# **Verification Report**

**Initial and first Verification  
of the CDM project**

**“Talía Landfill Gas Recovery and Electricity Production“  
in Israel**

**Report No. 982547, Version 2**

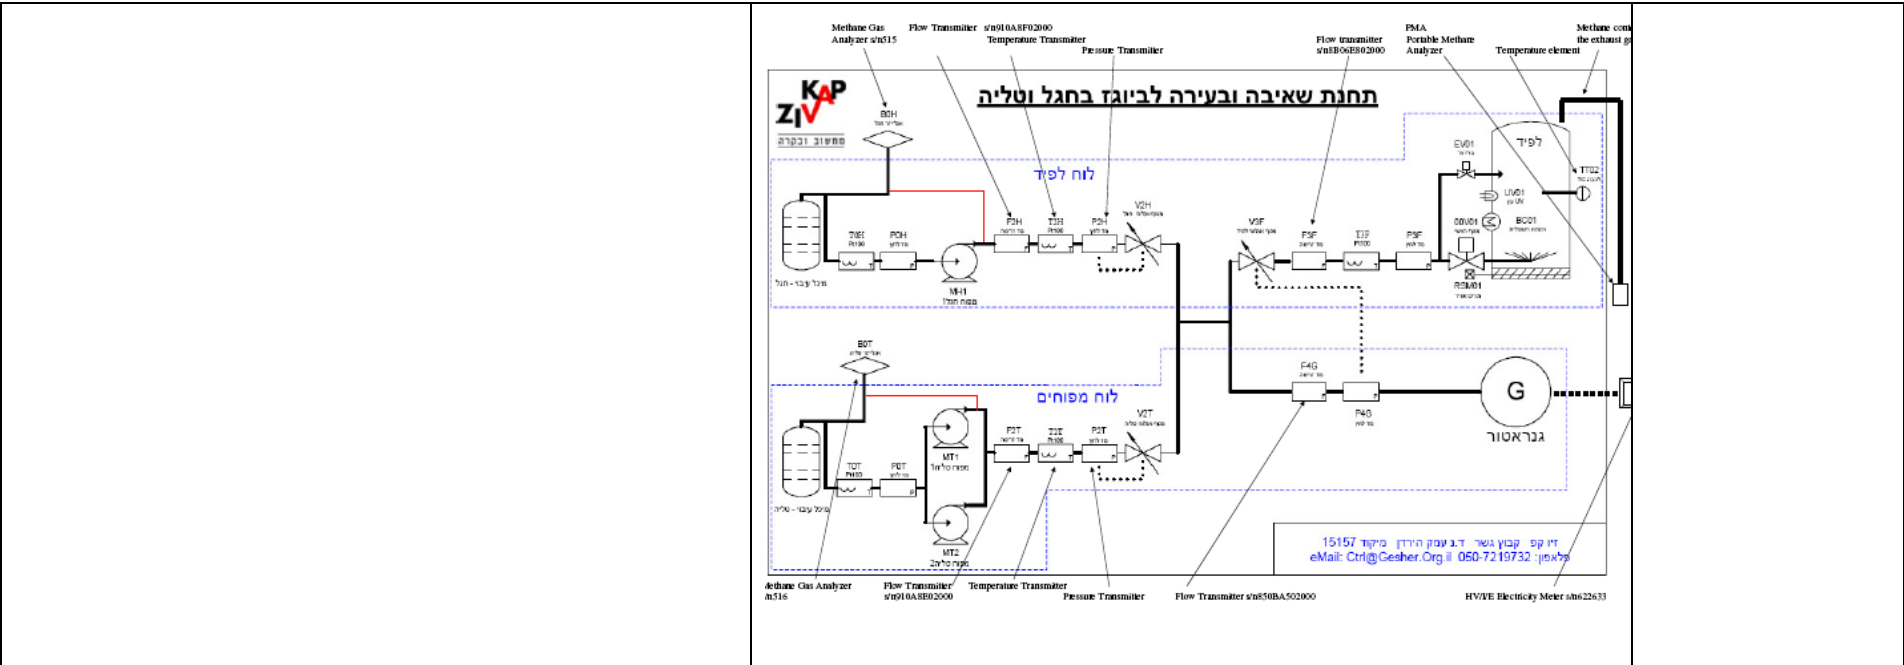
The primary analyzers were installed after blowers, but on later stage, according to requirement of EHEIM, location of analyzers was changed, ahead of the blowers.

For clarification of prevention of potentially cause additional air input, we can provide report of pressure test of piping . Is it OK for you?

The confirmation of changes in the monitoring architecture (to the order of devices: blower, methane analysis at both sites, flow meters) was submitted. Based on the latter the avoidance of measuring increased volumes (due to air input from blowers) is considered not to be possible.

to be very small (less than 1%, not systematic between landfill sites). However, in order to demonstrate conservativeness, the CH4 content measured previously to installation change were capped at 95% of the mean. The latter is considered conservative by the audit team.
